Access Compliance Report Public Rights-of-Way (Curb Ramps)

Main Street: MORNING_TRAIL Cross Street: OSO_PKWY Location: SW

ADA ID: RPRK211021123527 Ramp Type: Type 1 - Perpendicular Diagonal Initial Pass/Fail: Fail Overall Compliance: No Severity Score: 30

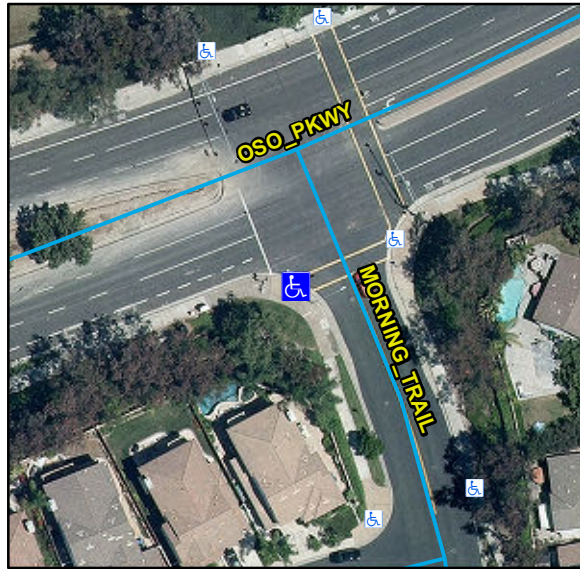
R304.2.2, R204.3, R304.5.3, STD 1115

Remove & Replace Curb Ramp With Two New Directional Ramps or Equivalent.
